Display

Subject: **CORRECTING SMEAR**

Model: **VPH-G70Q**

Serial No: **UP TO 2,000,580**

Figure 1

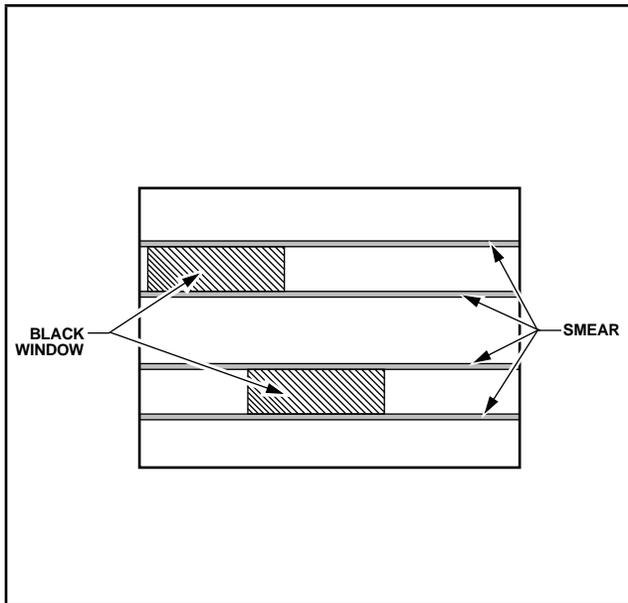
A high voltage current may undulate and a raster may become uneven when feeding a black window in white background, causing a smear to occur on the picture as shown in Figure 1.

To correct this condition, perform the following modification procedure.

Figure 2

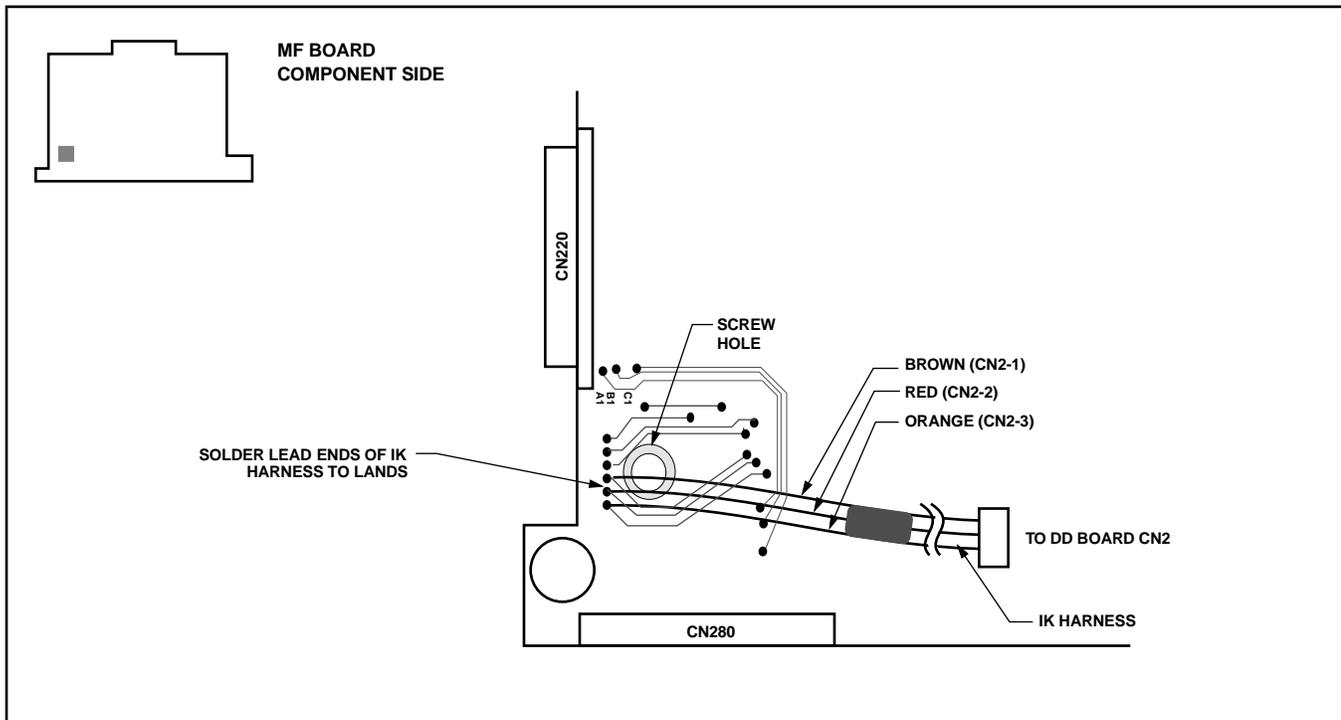
1. Install new IK harness connecting MF board and DD board as follows and as shown in Figure 2:

- a. Solder lead ends of new IK harness to lands on MF board (component side) between CN220 and CN280, near screw hole as shown.
- b. Connect other end of IK harness to DD board-CN2.

NOTE: Do not remove connector assemblies between C boards and MF board, since connector assemblies are clamped to other connector assemblies.

Figure 3

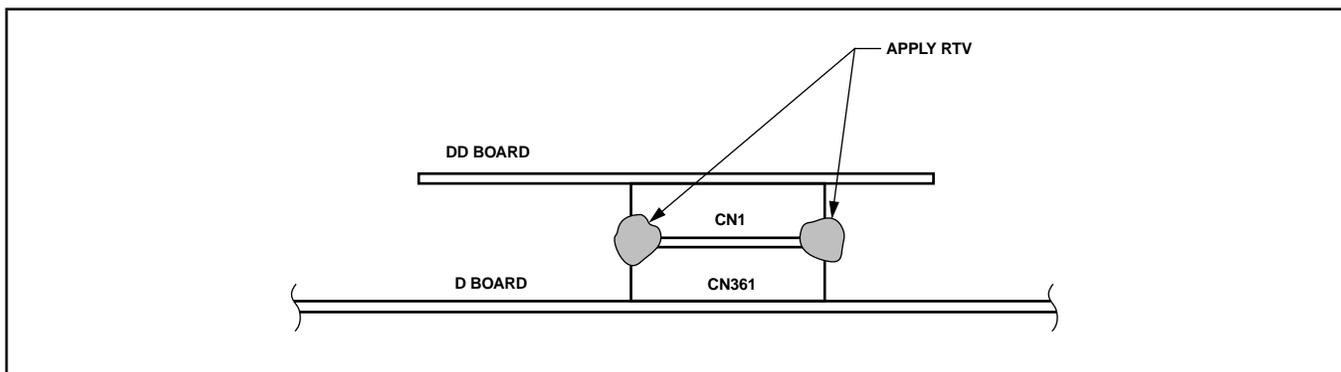
2. Replace former suffix -11 DD board with new suffix -12 DD board.

NOTE: Apply RTV to CN1 on DD board, and CN361 on D board, connecting the two boards as shown in Figure 3.

Figure 4

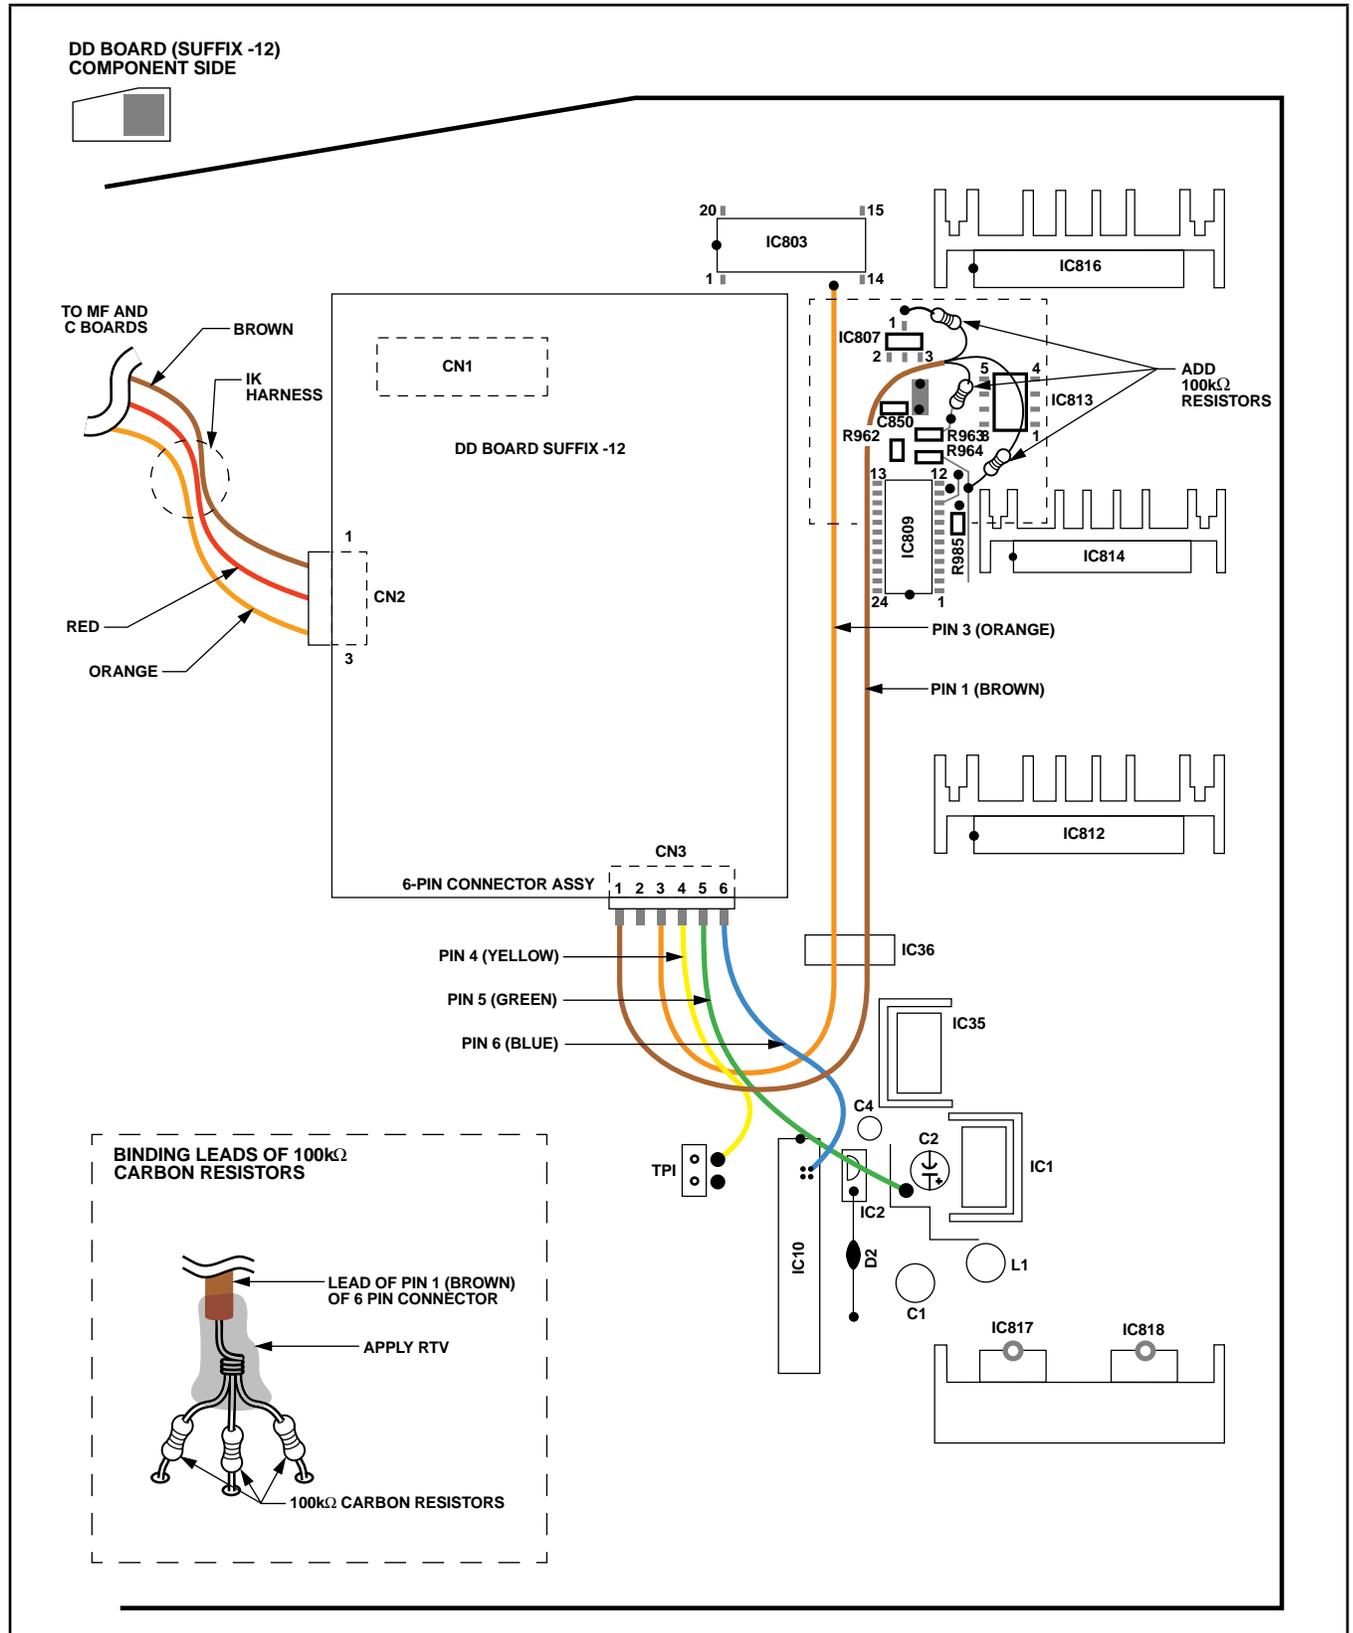
D Board (Component Side, Zone A/B-18)
(See Figure 4.)

3. Connect 6-pin connector assembly as follows:
 - a. Connect one end of connector assembly to CN3 on DD board as shown.
 - b. Solder pin 3 (orange) lead to pin 10 of IC803.
 - c. Install three 100kΩ carbon resistors as follows:
 - Solder one lead of first resistor to thru-hole near pin 1 of IC807.
 - Solder one lead of second resistor to thru-hole near pin 6 of IC813.
 - Solder one lead of third resistor to thru-hole below R964.
 - d. Twist pin 1 (brown) lead of 6-pin connector assembly around unsoldered leads of carbon resistors, to bind leads together as shown in Figure 4, inset.

(Zone F-18)

- e. Solder pin 4 (yellow) lead to thru-hole of GND trace near TP1.

- f. Solder pin 6 (blue) lead to thru-hole of -12V bus near IC2.
- g. Solder pin 5 (green) lead to thru-hole of +12V bus near C2.

Figure 1

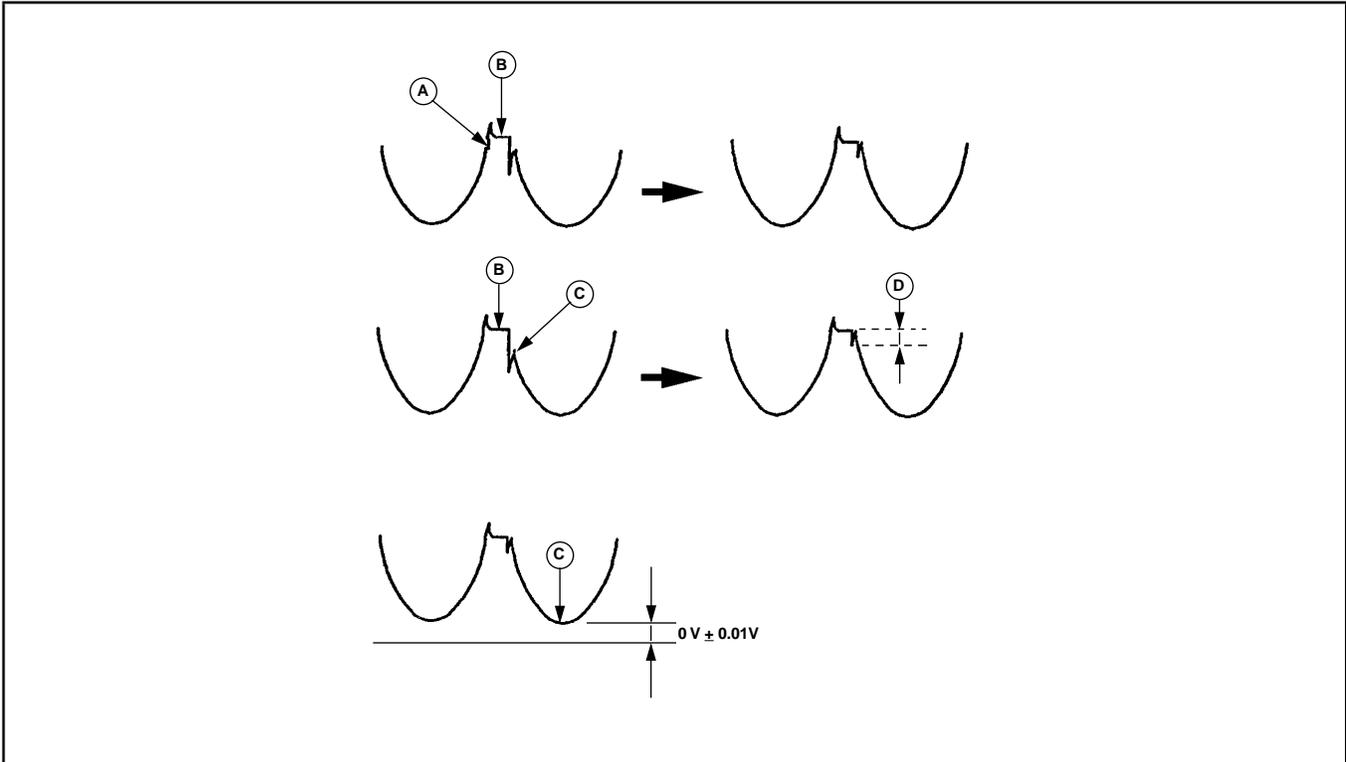
- c. Adjust RV2 so that level (a) becomes the same as level (b).
- d. Adjust RV3 so that level (c) becomes the same as level (b) and spike (d) is minimized as shown.
- e. Adjust RV1 so that level (e) becomes DC 0V±0.01V.
- f. Repeat sub-steps c through e to perform tracking.

(See Figure 5.)

1. Adjust DD board suffix -12 as follows:
 - a. Set fH frequency to 64kHz, using internal oscillator or external signal.
 - b. Connect oscilloscope to TP1 and TP2 (GND).
2. Adjust registration for each channel, even if waveform adjustment has been performed, since waveform of DD board suffix -12 differs from that of suffix -11 board.
